Tech Bulletin - Rockcrawler Side Guards - CJ, YJ and TJ*

1/8" thick x 2" o.d. washers

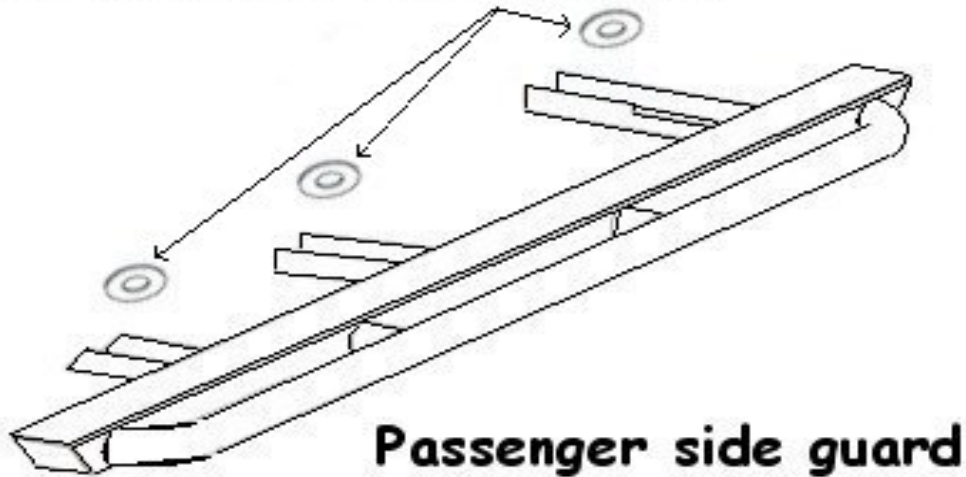
There have been several cases of squeaking coming from the installation of our side guards on models with worn or over-compressed body mount bushings. This issue has been found mostly on TJ's, though there have been reports from at least one CJ and YJ owner. The issue has been identified as the top of the mounting channels slightly rubbing the underside of the body-mount outriggers during frame twist from entering and / or exiting uneven driveways, dips, etc. The only solution is to shim the mounting channels on the body-mount bushings to space the channels down and off the outriggers.

If you encounter squeaking after installing your side guards, a simple 1/8" thick x 2" o.d. washer between each channel and body-mount bushing will space the channels off the outriggers just enough to resolve and prevent this noise.
